## McClellan Air Force Base

Davis Global Communications Site

# Remedial Investigation/ Feasibility Study Report

SUBJECT: Final Copy, Remedial Investigation/Feasibility Study (RI/FS) Report, Davis  
Global Communications Site

**FIGURE B-2**  
**AIR PERMEABILITY TEST AT CH-4**  
 DAVIS GLOBAL COMMUNICATIONS SITE  
 MCCLINTOCK AIR FORCE BASE

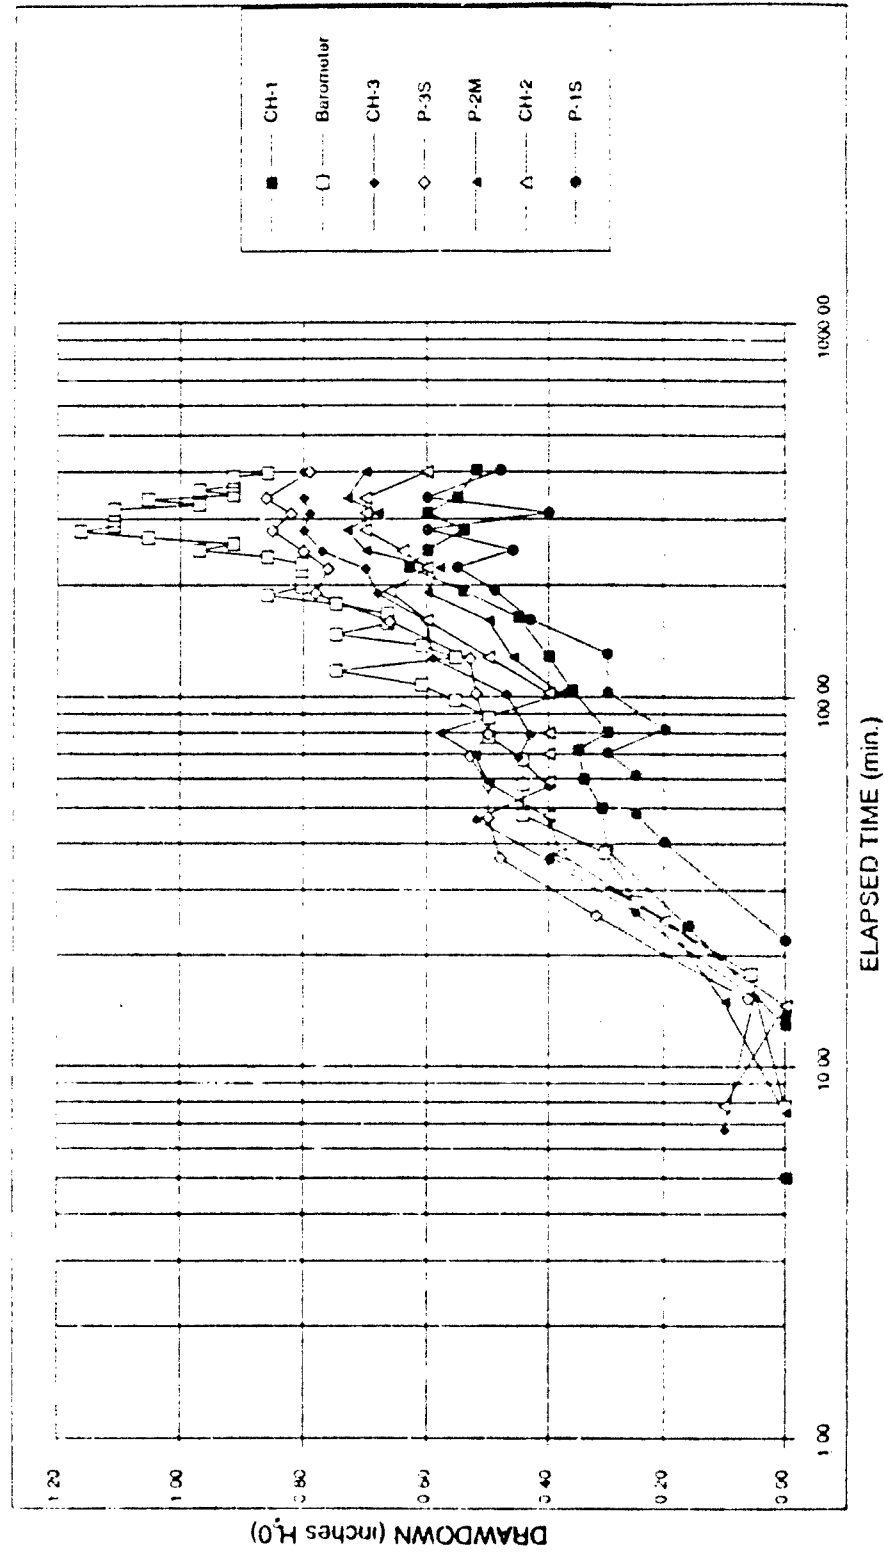
2. Figure B-2. The response of the SVMWs and piezometers are suspiciously matched to the barometric pressure. Can you provide any insight to the correlation? The data for the air permeability tests at CH-1 and 5 do not appear to correlate as closely.

**FIGURE B-4  
CONTOURS FOR AIR  
PERMEABILITY EXTRACTION  
TEST AT CH-1**  
DAVIS GLOBAL COMMUNICATIONS SITE  
MCLELLAN AIR FORCE BASE  
YOLO COUNTY, CALIFORNIA

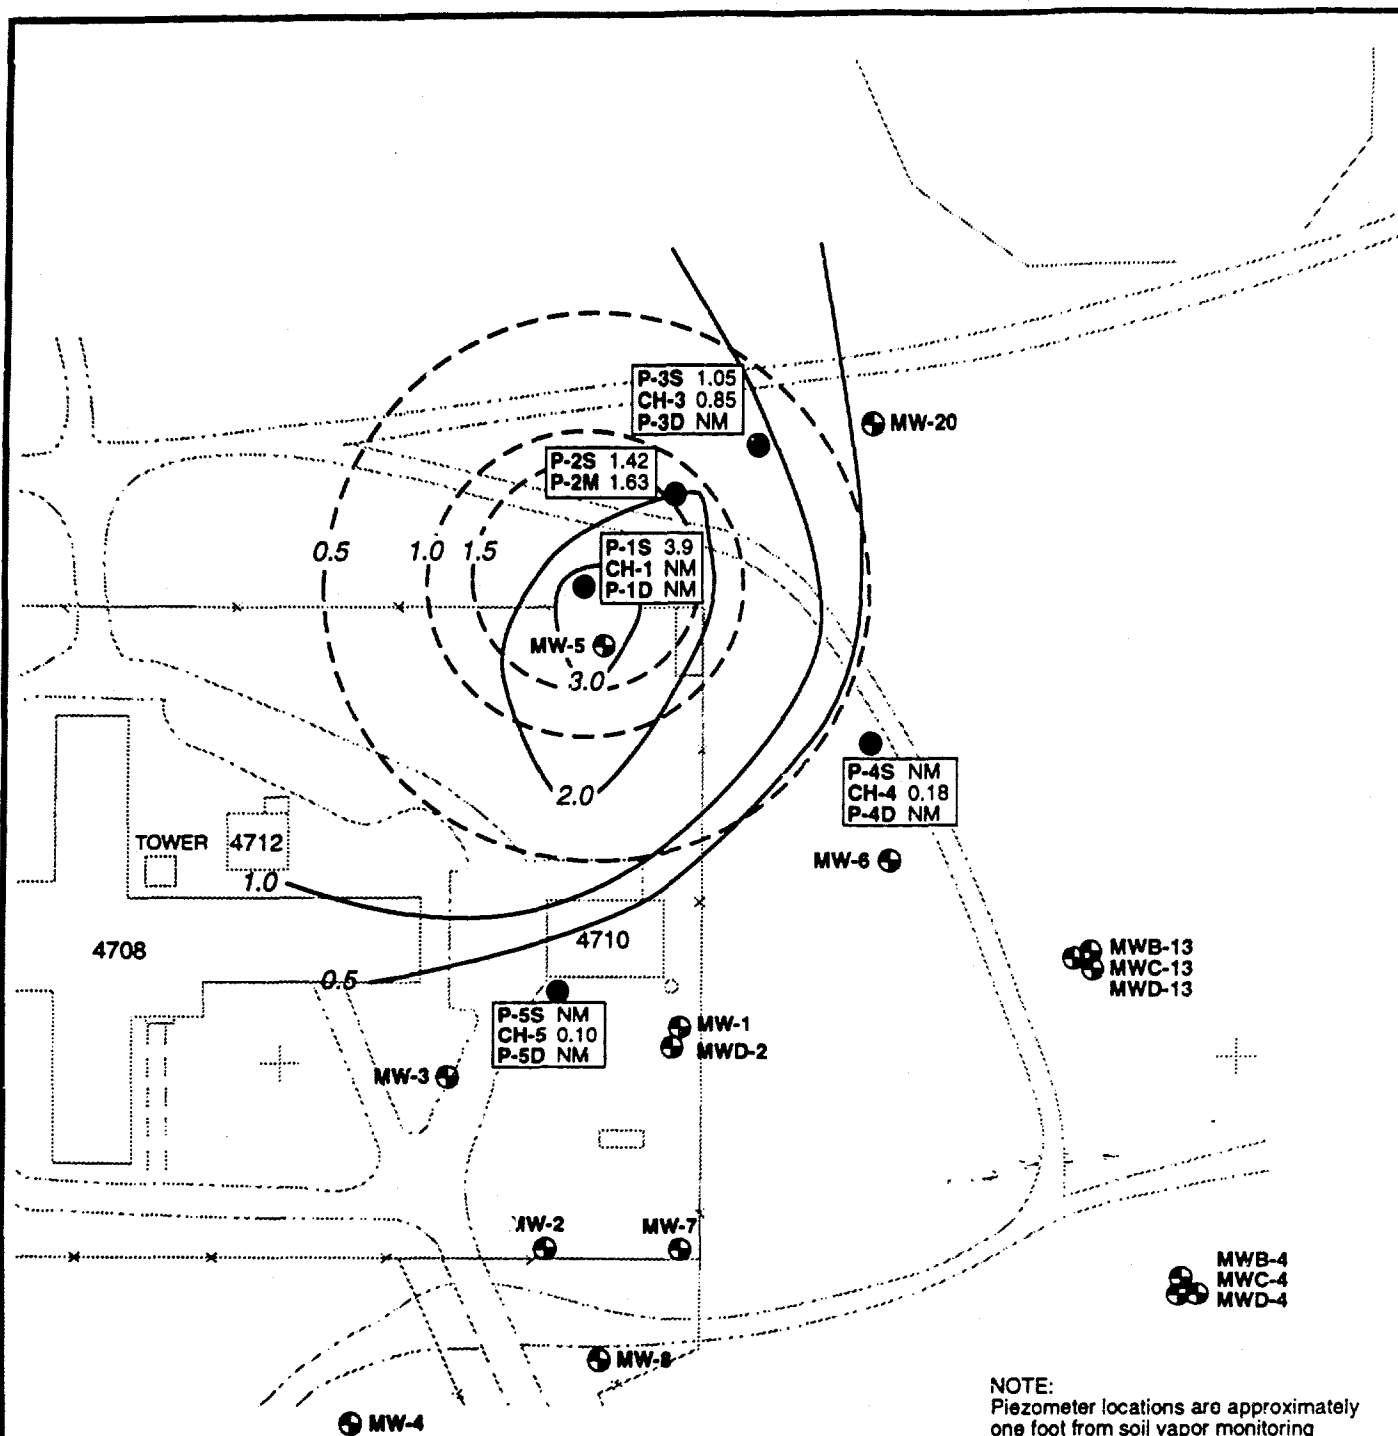
1.	B-2		Provide a map showing the five SVMWs and nine piezometers locations. Specify the dates of the tests and the most recent rainfall event and amount of precipitation.
2.	Fig B-2		The response of the SVMWs and piezometers are suspiciously matched to the barometric pressure. Can you provide any insight to the correlation? The data for the air permeability tests at CH-1 and 3 do not appear to correlate as closely.
3.	B-17	1	Is it possible that the biological activity (no measured oxygen) caused the positive pressure observed in the CH-3 well?

The five soil vapor monitoring wells and nine piezometers are shown on Figure B-4. The dates of the tests and the most recent rainfall event are shown in Table B-1.

**FIGURE J-19**  
**OPERATION SCHEMATIC**  
**FOR EXTRACTION SYSTEM**  
DAVIS GLOBAL COMMUNICATIONS SITE  
McCLELLAN AIR FORCE BASE  
YOLO COUNTY, CALIFORNIA

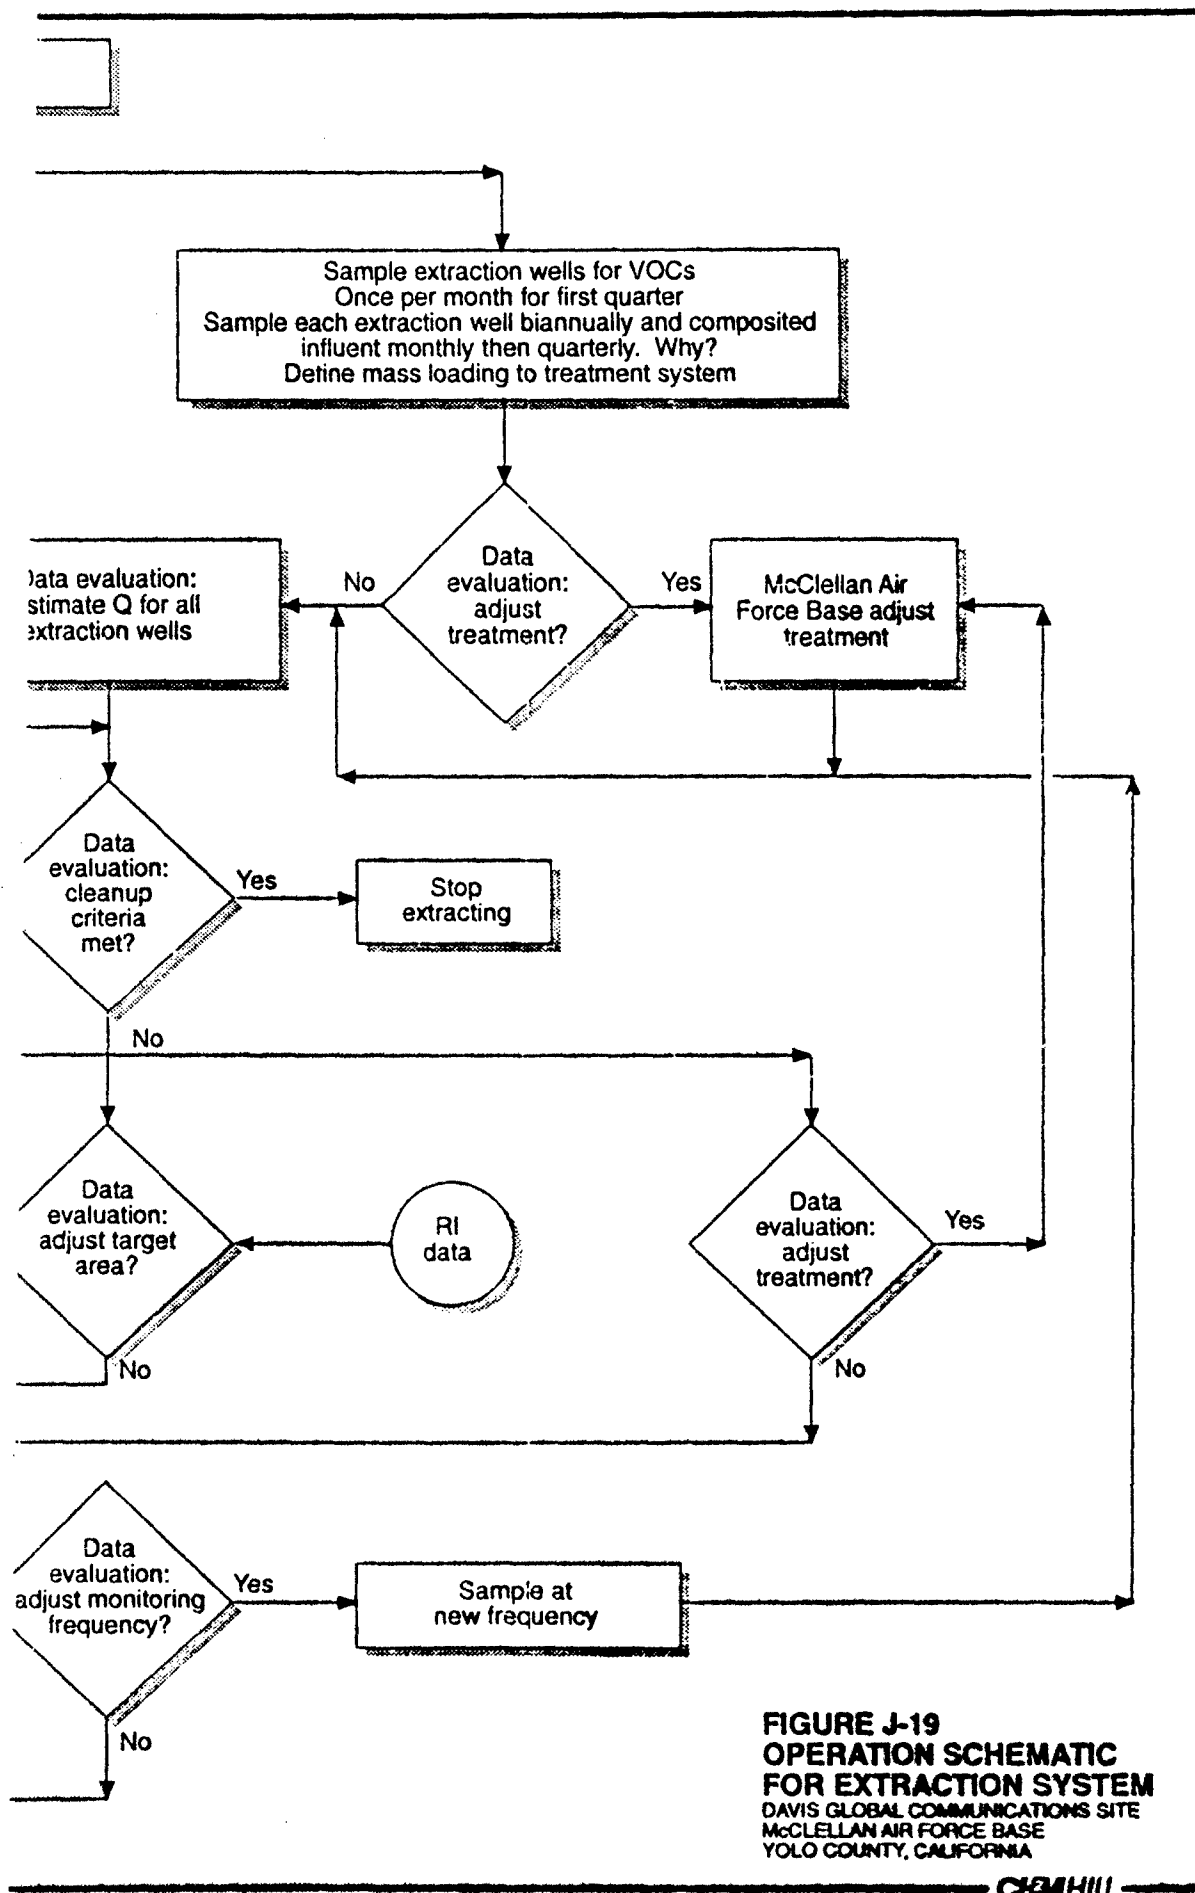
10. **Appendix J, Figure J-19. The first decision diamond on the right side of the flow diagram does not have a "Yes" path associated with it. Two other decision diamonds have two arrows leading from them but only the "no" path is delineated.**

9. **Figure J-19. AG pumping Diamond - Define a time period (i.e. 2-3 weeks). Adjust Q Box - It may not be necessary to adjust "all" well(s). The logic for the two "Adjust Target Area" Diamonds is not clear. What is the difference between the McAFB adjust treatment box and the previous adjust treatment decision diamond and why does the McAFB adjust treatment box lead into another adjust treatment diamond? The "No" direction "clean-up criteria met?" diamond, should flow to all three decisions, "adjust target area?", "adjust treatment?" and "adjust monitoring frequency?". After the first quarter, how often will influent be sampled?**

10. Appendix J, Figure J-19. The first decision diamond on the right side of the flow diagram does not have a "Yes" path associated with it. Two other decision diamonds have two arrows leading from them but only the "no" path is delineated.
